Re: New Office/ Warehouse

3831 Masthead St. NE

**Conceptual Traffic Circulation Layout for DRB Approval**

Engineer's Stamp 10-07-22 (D17-D095A)

SITE DEVELOPMENT PLAN

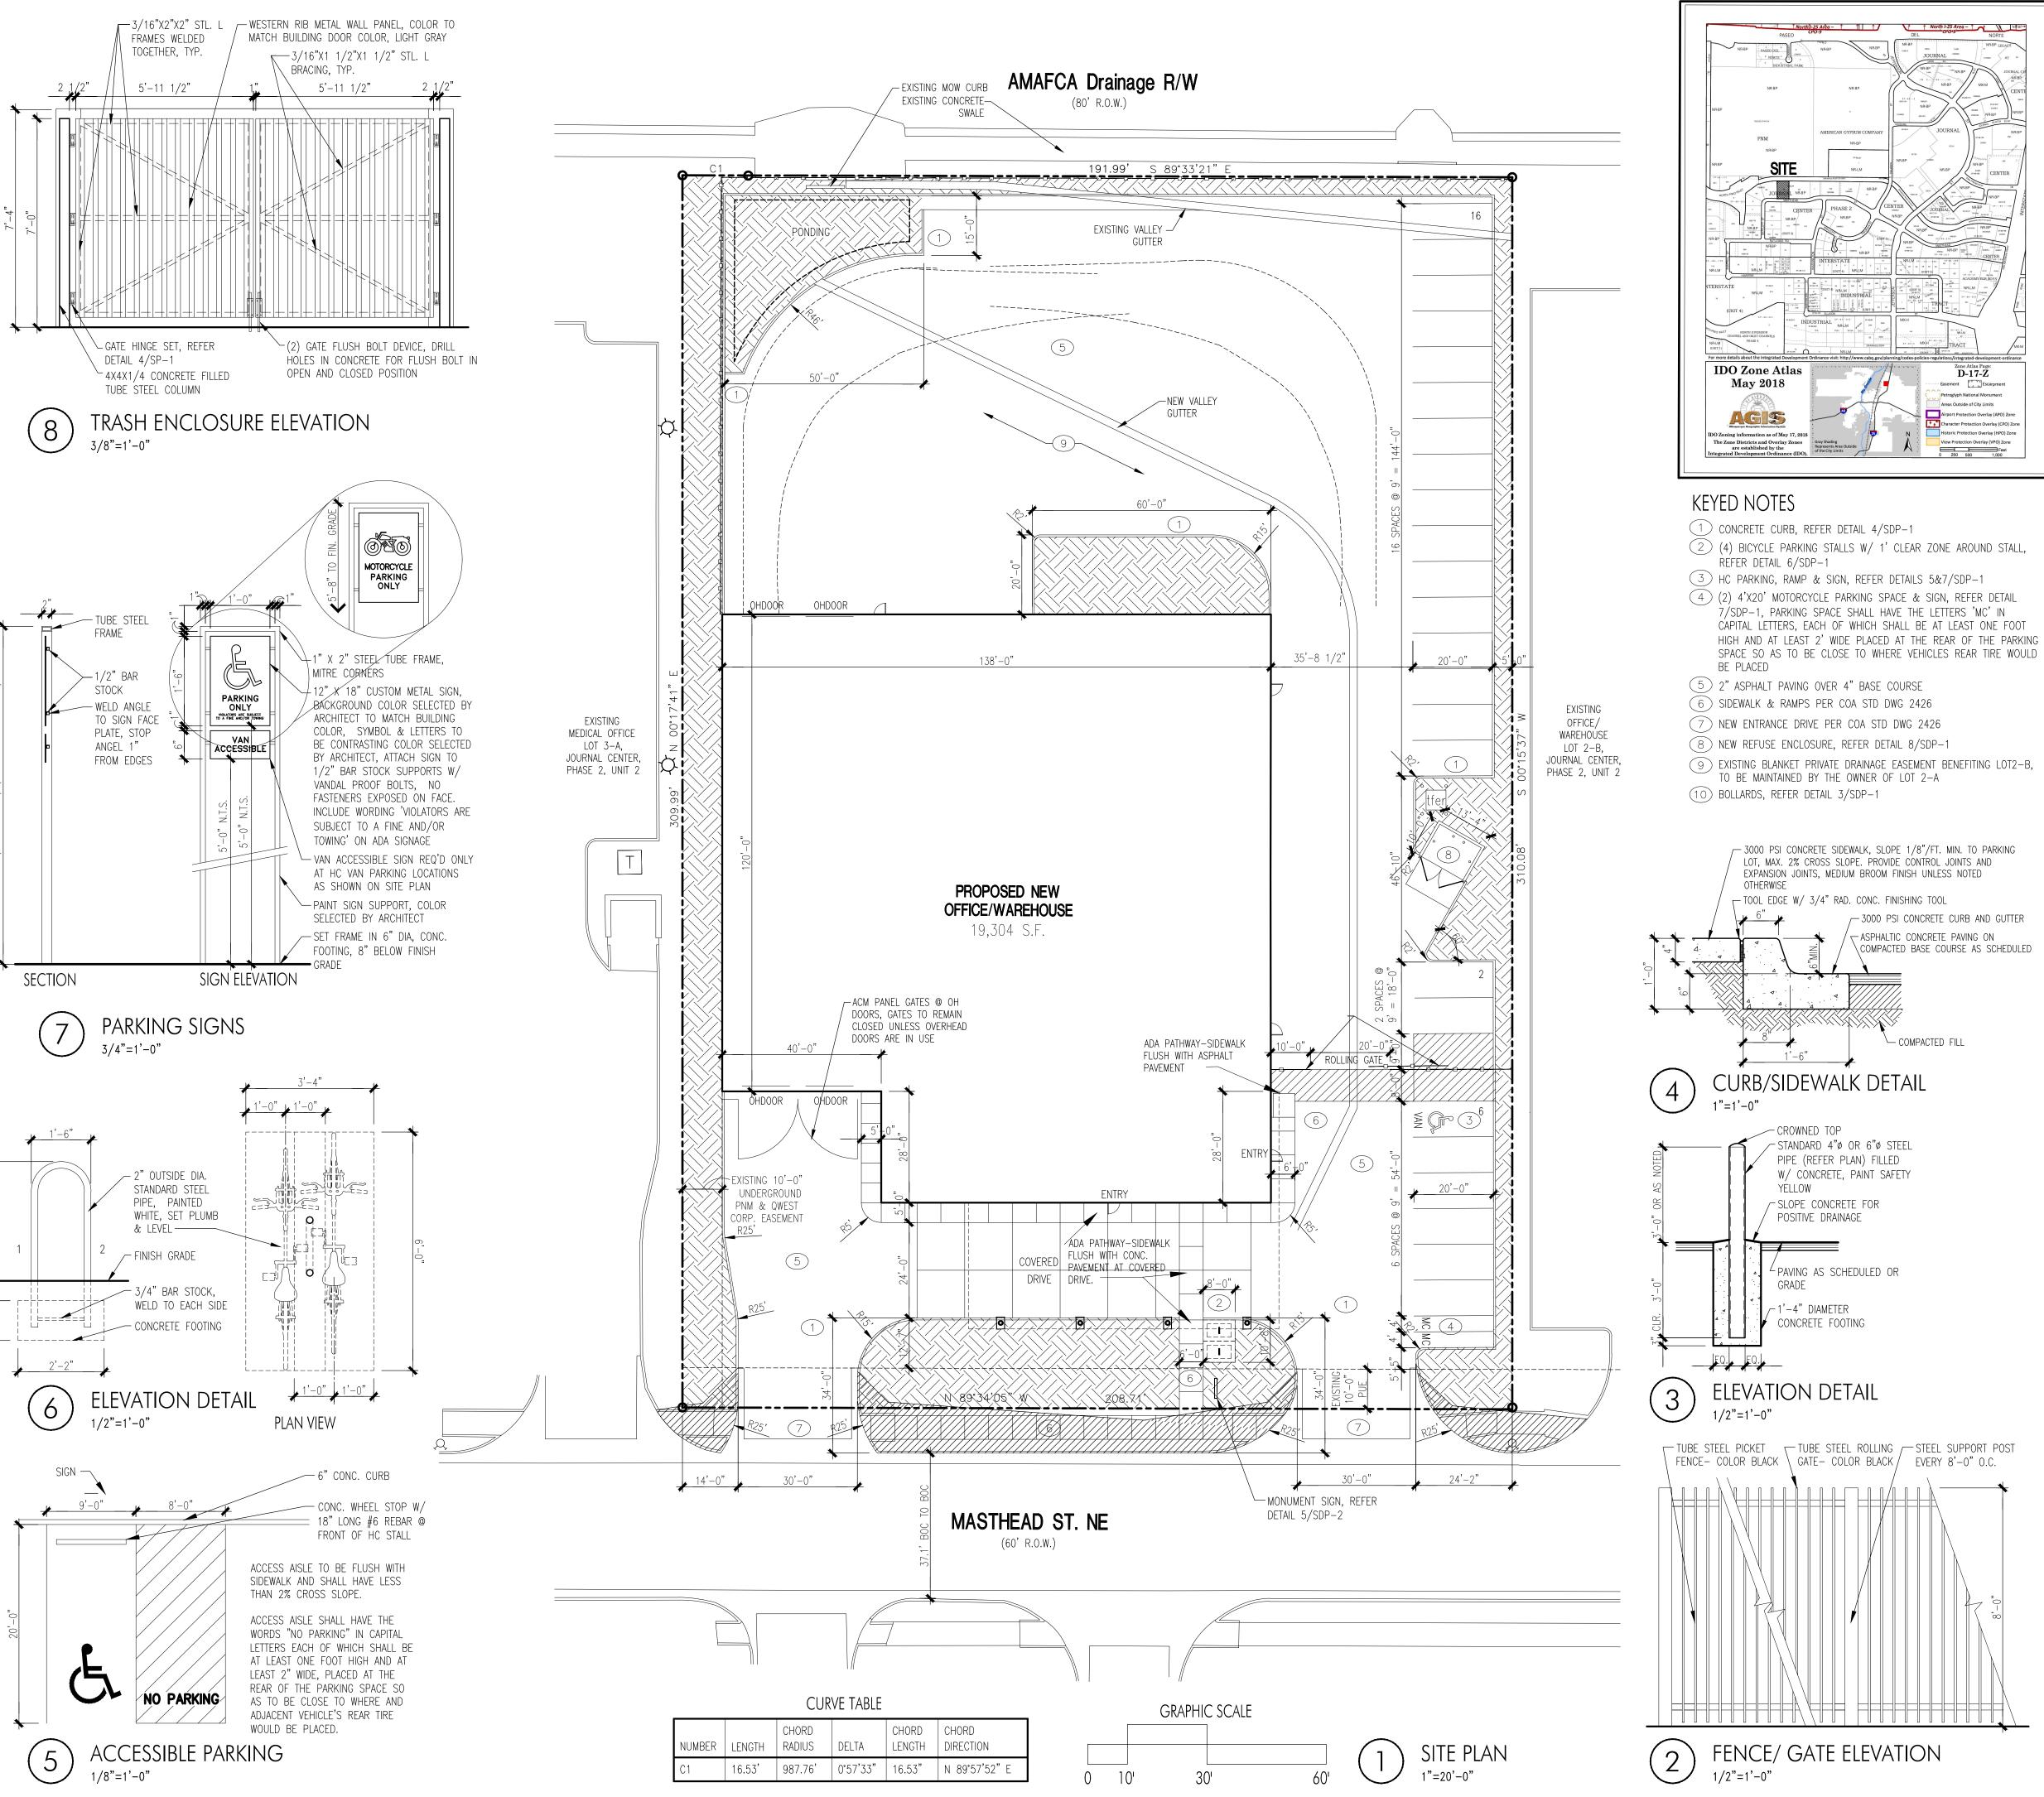
The conceptual TCL submittal received 09-14-2022 is approved for DRB submittal. When submitting this project through the building permit process, please provide a copy of the approved DRB Site plan along with a more detailed site plan for construction purposes through a second Traffic Circulation Layout submittal process. The detailed plan will be compared against the approved DRB site plan to ensure that all previously approved site infrastructure is shown with exact paving layout, dimensioning, and parking capacity. Ultimately, a copy of the approved DRB Site Plan and the more detailed stamped and signed plan will both be needed for each of the building permit plans. Please keep these originals to be used for certification of the site for final C.O. for Transportation.
